Hamilton Community Center & Ice Arena Chiller Plant & Women's Locker Room Shell Addition

ADDENDA #2

- A. Project Name: Hamilton Community Center & Ice Arena Chiller Plant & Women's Locker Room Shell Addition
- B. Owner: Park and Recreation Department, City of Columbus
- C. Architect: atelierRISTING LLC
- D. CMA: Taylor Bros. Construction Inc.
- E. Date of Addendum: 11 December 2024

**ADDITION
FLOOR PLAN**

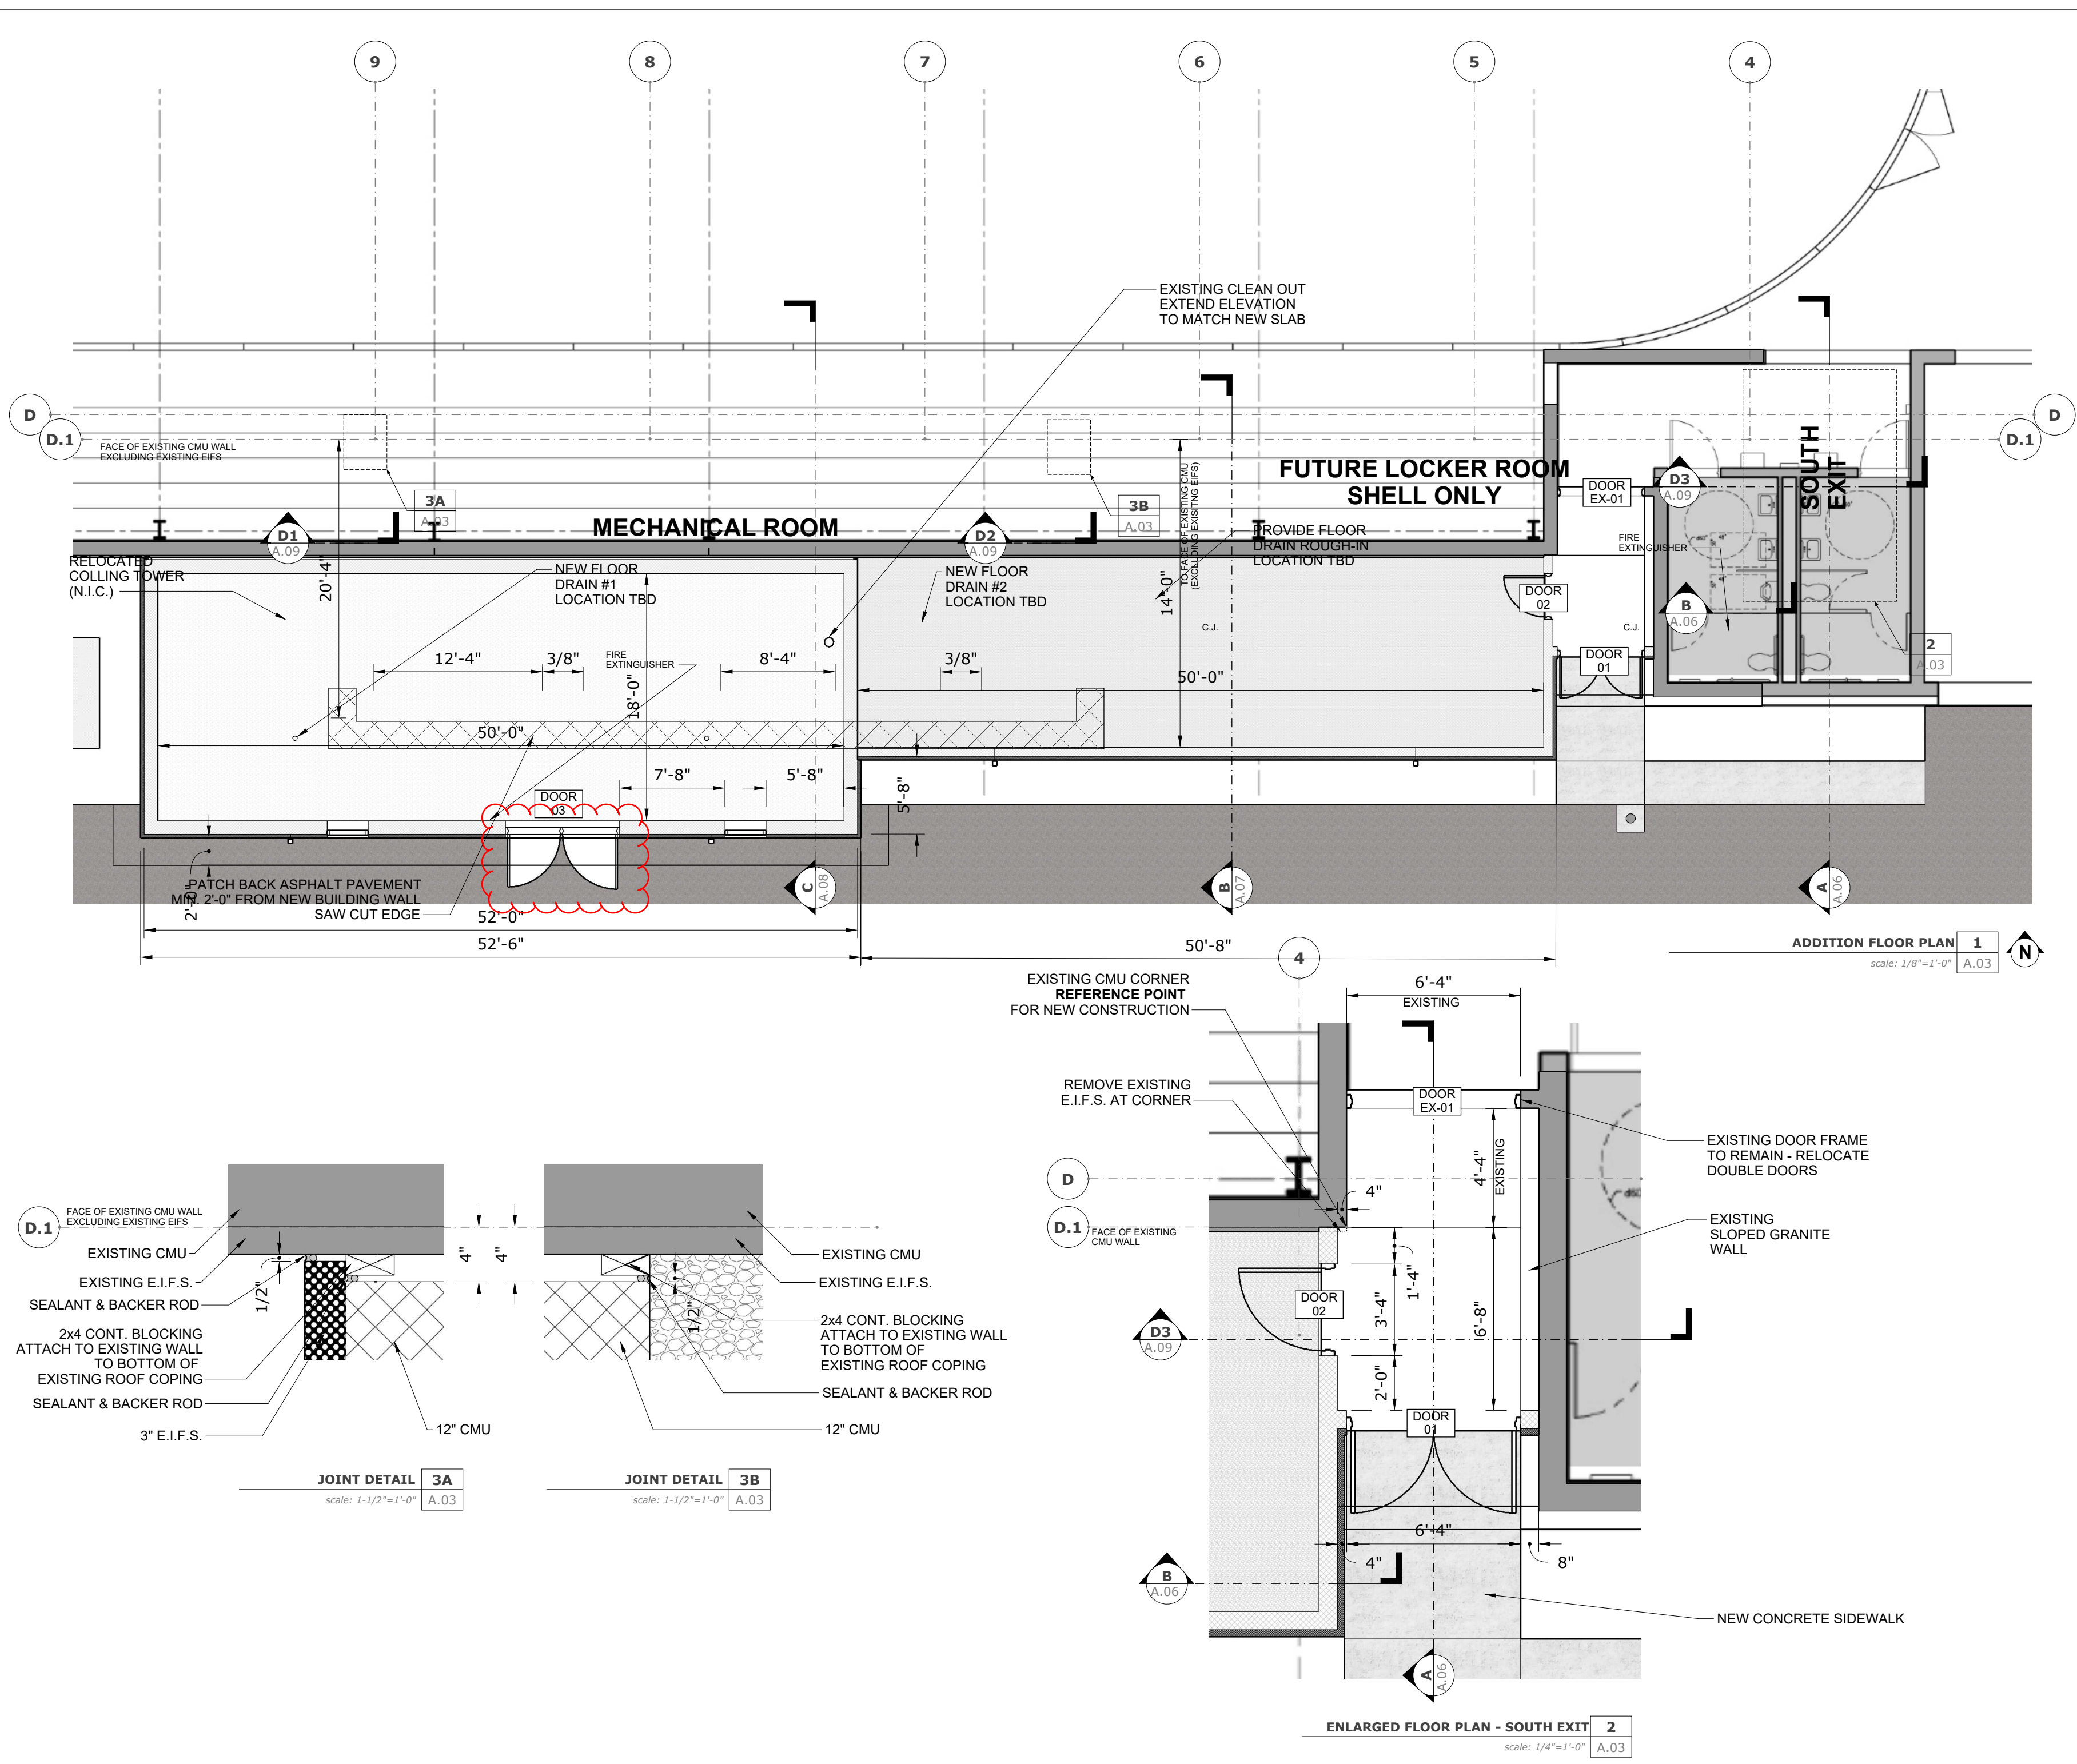
1. 1/A.03 FLOOR PLAN - Door 03 revised

SOUTH ELEVATION 1
scale: 1/8"=1'-0" A.05

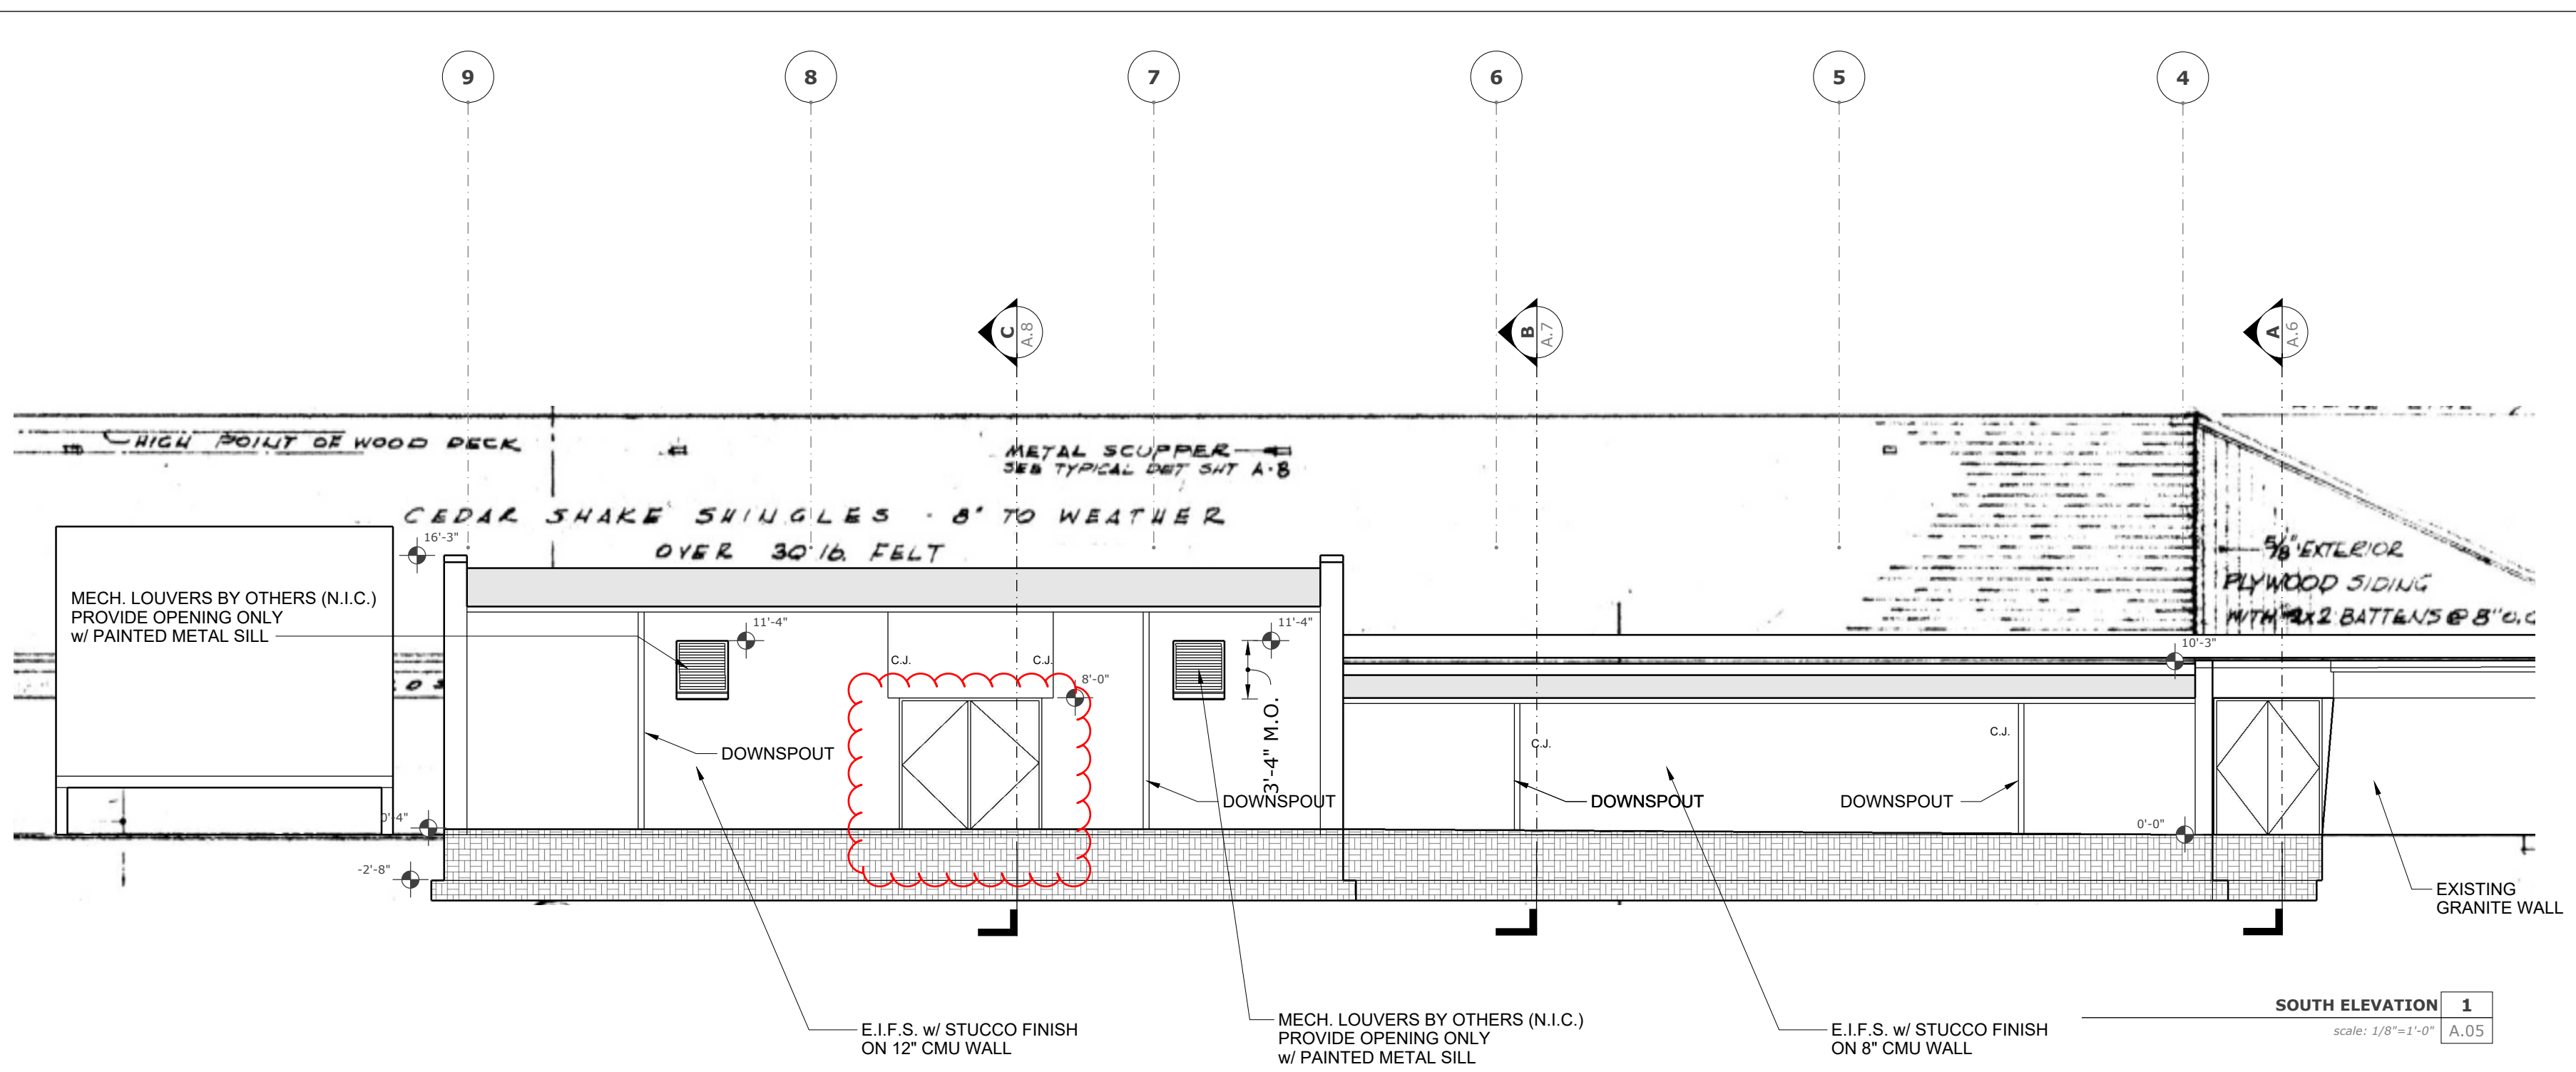
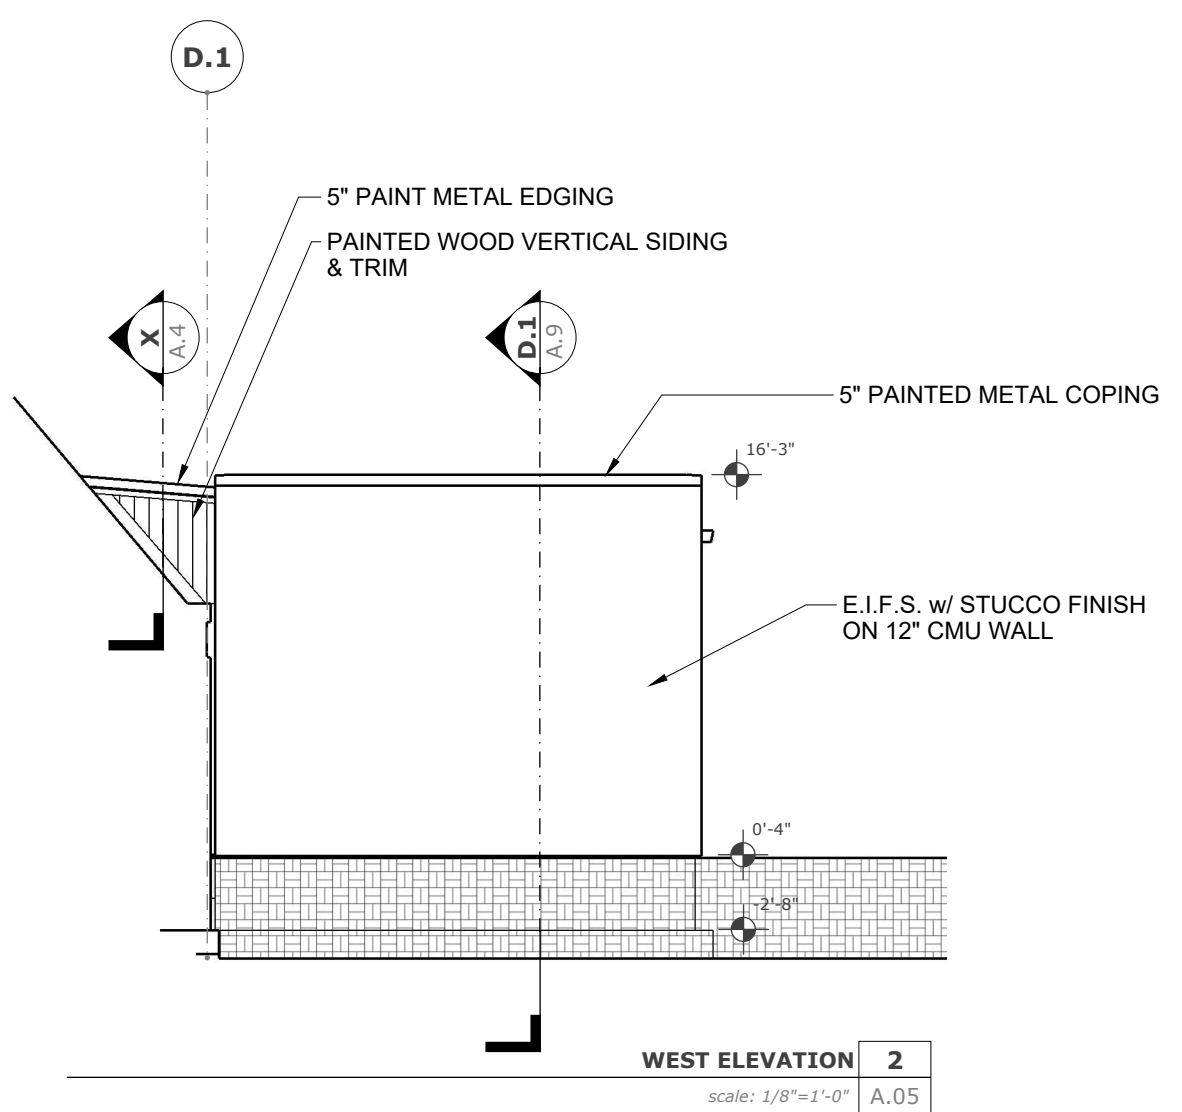
1. 1/A.03 SOUTH ELEVATION: Door 03 revised

FR3 - MECHANICAL ROOM

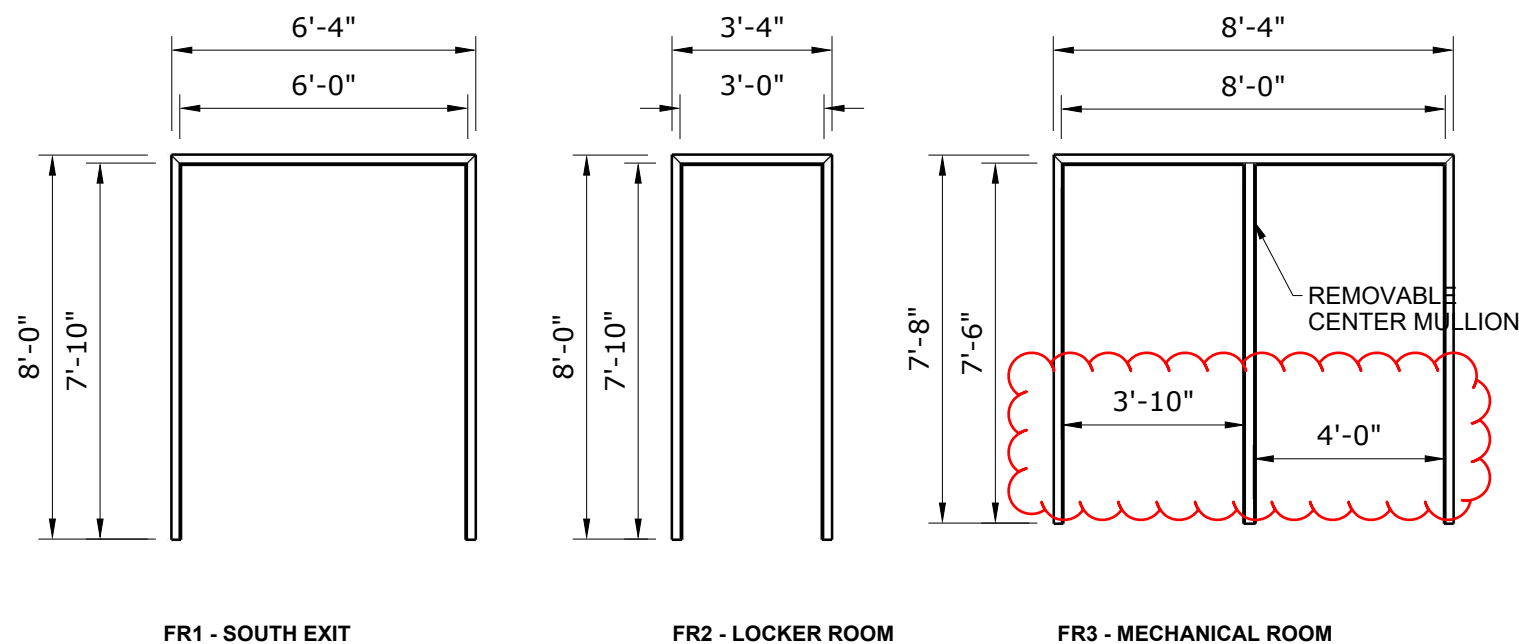
1. REVISE DOOR 3 MECH. ROOM door width to 3'-10" (with panic hardware) and 4'-0" (with bolt), in lieu of 3'-0" and 4'-10" widths.
2. REVISE FR3 DOOR FRAME dimensions to match door widths above.
